Point-to-point Electrical Specifications

Constraints/Other Specifications

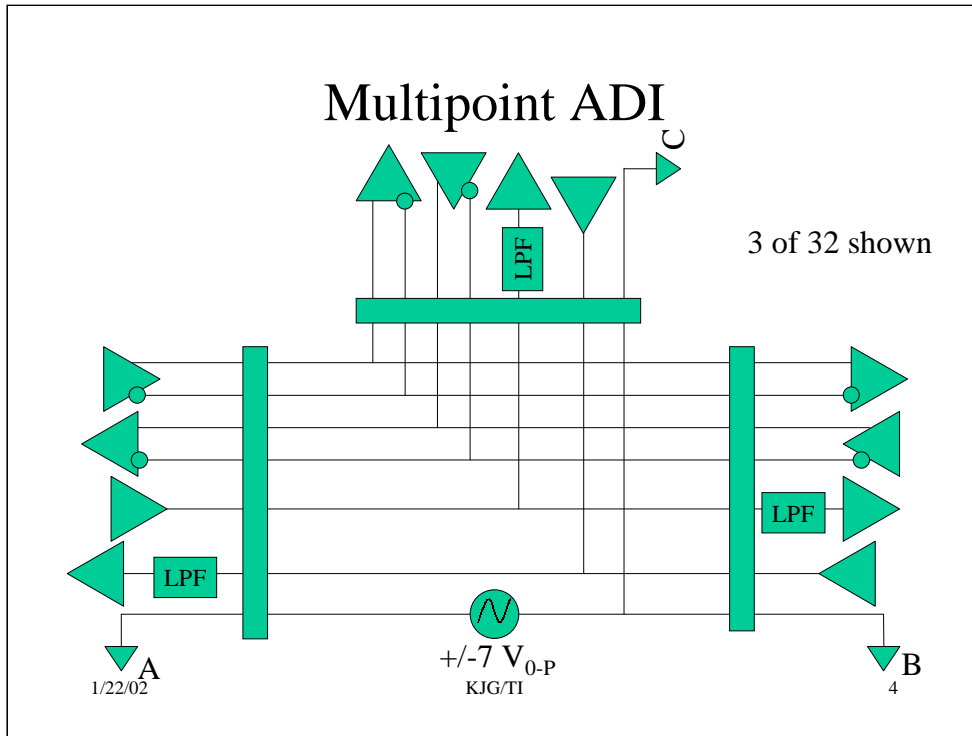
For the sender, 404 specifies the quality of binary data signals employing start-stop (asynchronous) format at a data terminal equipment interface. There are different categories provided with different spec limits. Exceptions to the interface measurement requirements may be warranted for ADI.

Will the single-ended lines be allowed to bounce or oscillate during transition? If so, for how long?

What should the default state be for open inputs? How should the equipment respond?

If the cable is to carry signal return or is shielded, how should it be terminated to prevent ground loops?

If multipoint connection is to be allowed, the electrical requirements change.
